# IRA BCT Scoping Meeting Summary

**Date of Call:** 10/07/2020

# IRA Scoping

Former Wurtsmith Air Force Base

# Cross-Section at Van Etten Lake

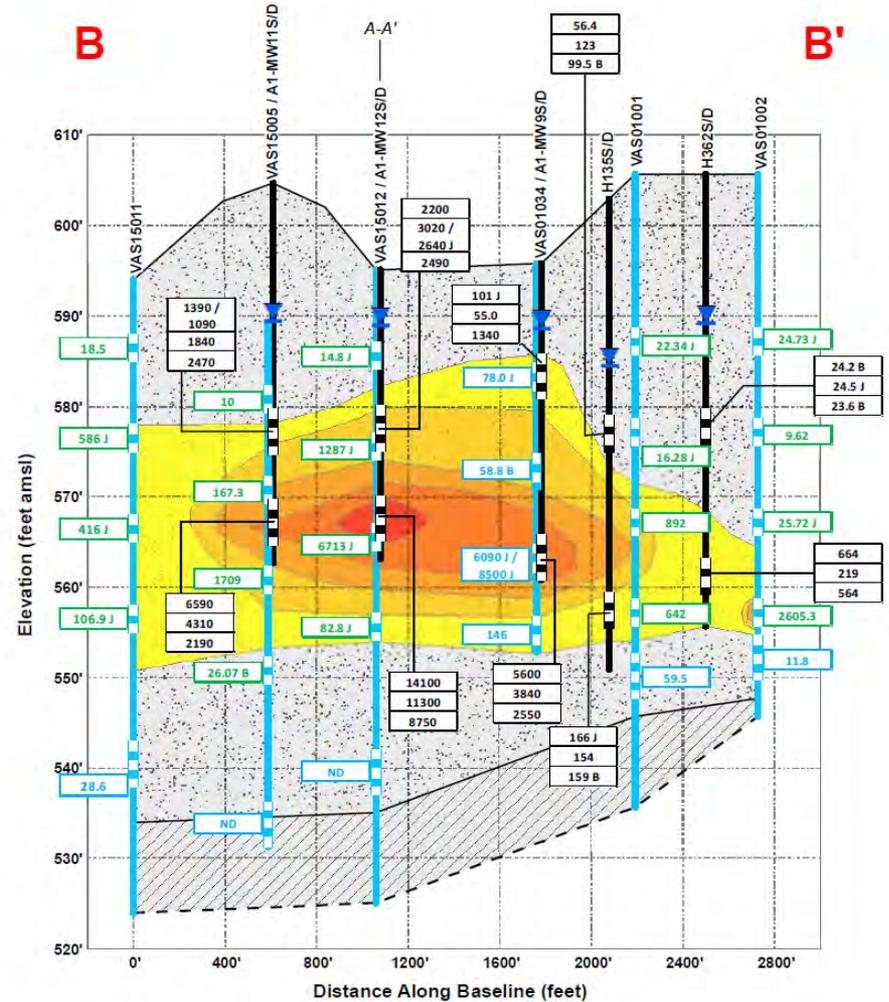
tracks extending into the water. Figures demonstrating the modeled particle tracks and treatment system layout were presented. A cross-section illustrating the plume configuration and concentration near the proposed extraction well boundary was also provided (see attached slides). EGLE (Ms. Place) asked to confirm if the new system will be designed to meet cleanup criteria. The system will be designed to meet the SRD requirements as these IRAs are not the final solution; the systems are to provide a hydraulic barrier against the high PFOS/PFOA mass areas.

# Clark's Marsh Preliminary Extraction Well Locations and Capture Zones

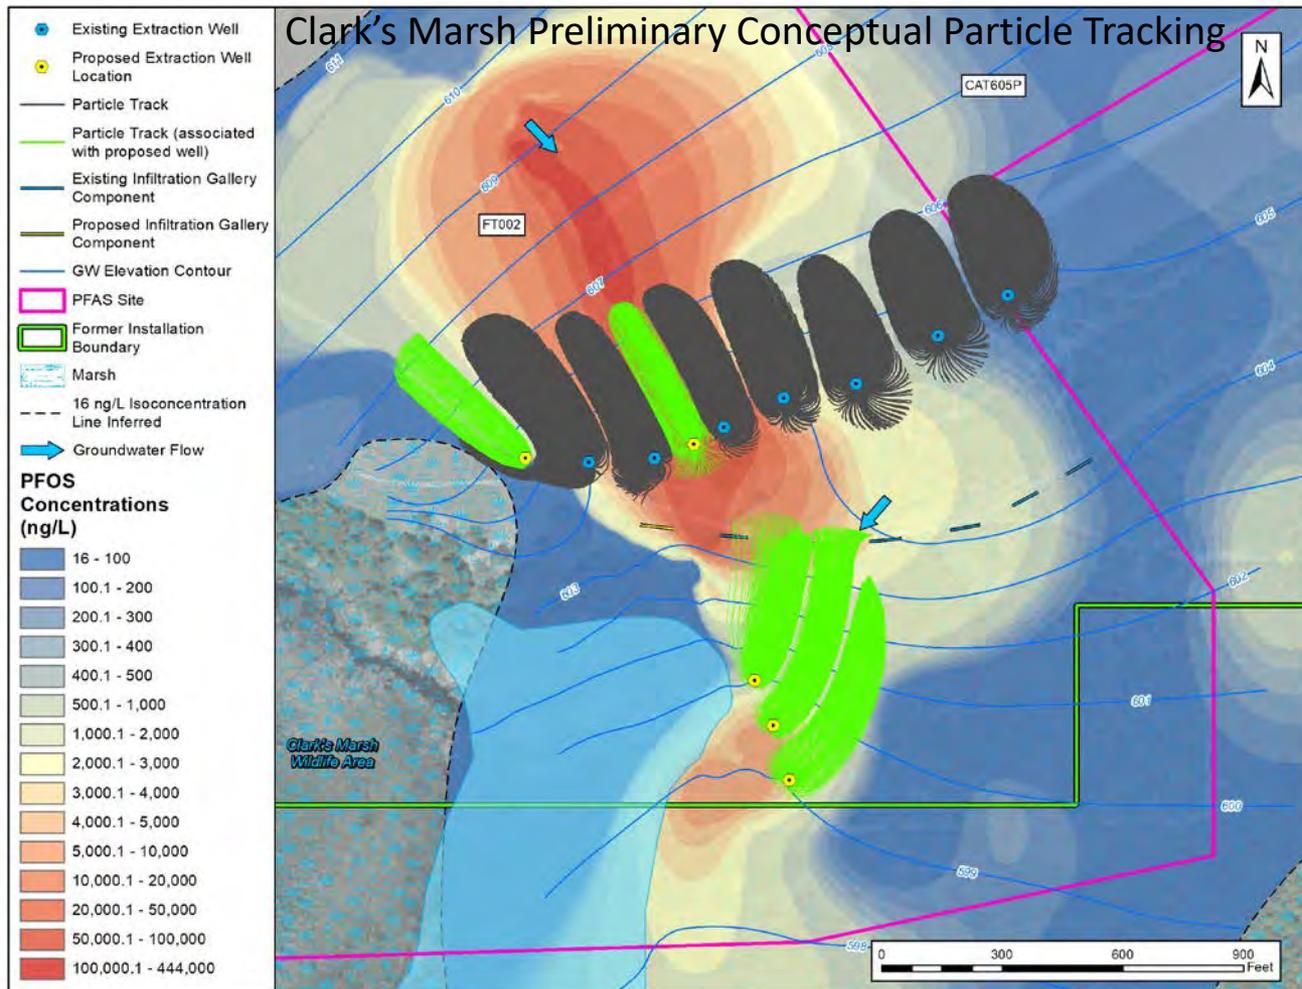
The most westerly proposed infiltration gallery component, as shown on slide 17, will not be installed because it is very close to LF027. Model projections estimate a total extraction rate for the 12 existing/new extraction well system at 310 gallons per minute. An additional 20,000-gallon GAC unit will be added to the existing treatment train to serve as a sacrificial vessel similar to the CTS.
